DETERMINATION OF NON-SIGNIFICANCE

FILE NUMBERS: 12-128151 LP and 12-132769 LD **PLANNER:** Toni Pratt, Senior Planner

City of Bellevue
Development Services Department
Land Use Division

Proposal Name:	**GRE Bellevue**
Proposal Address:	2211 156th Avenue NE & 2070 Bel-Red Road
Proposal Description:	Master Development Plan and Design Review approval to construct four multi-family residential towers over above-grade and underground parking. Approximately 476 parking stalls will be provided along with site landscaping. The project will consist of 452 apartments ranging from studios to two-bedroom units. Site access will occur from 156th Avenue NE and Bel-Red Road. Site size is 4.32 acres within the BR-RC-3 zone.
File Number:	**12-128151 LP and 12-132769 LD**
Planner:	Antoinette Pratt, Senior Planner
Applicant:	GRE Bel-Red, LLC
Decisions Included:	Maser Development Plan and Design Review Approvals
State Environmental Policy Act Threshold Determination:	Determination of Nonsignificance Carol V. Helland Carol V. Helland, Environmental Coordinator Development Services Department
Director's Recommendation:	**Approval with Conditions** Michael Brennan, Director Development Services Departm

East/West Pedestrian Connection via public Elevator

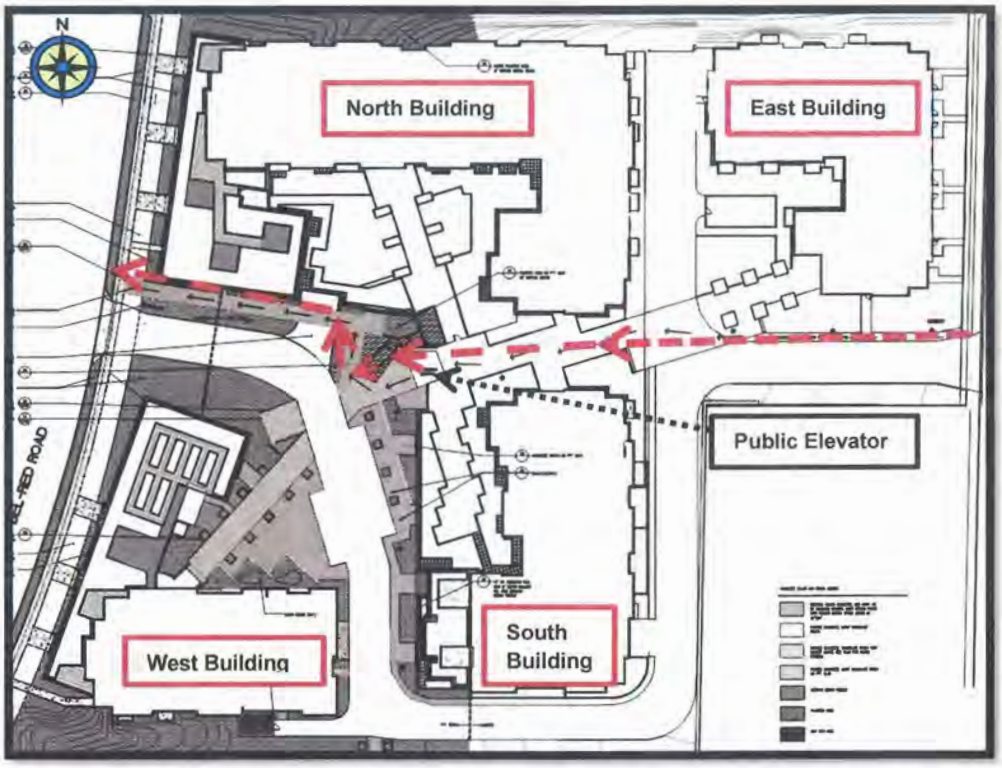
1. No public pedestrian path was proposed with the initial submittal of this proposal. Later revisions now show a pedestrian connection along with amenities along the east/west pedestrian route of travel. A public elevator will provide public pedestrian access during business hours. Access to the route of travel may be closed to the public after-hours. Signage detailing this pedestrian route of travel and its hours of access will be required prior to Certificate of Occupancy. See Section XIII for related condition.

Response: A pedestrian route of travel has been created across the site to connect with the major rights-of-way: 156th Avenue NE and Bel-Red Road. Sheet L1.01 details the route with arrows from east to west which is the major pedestrian route. As noted earlier in this report, there is a topographic differential of up to 20 feet across the site. A pedestrian elevator was added to address this topographic difference adjacent to the water feature at the center of the site.
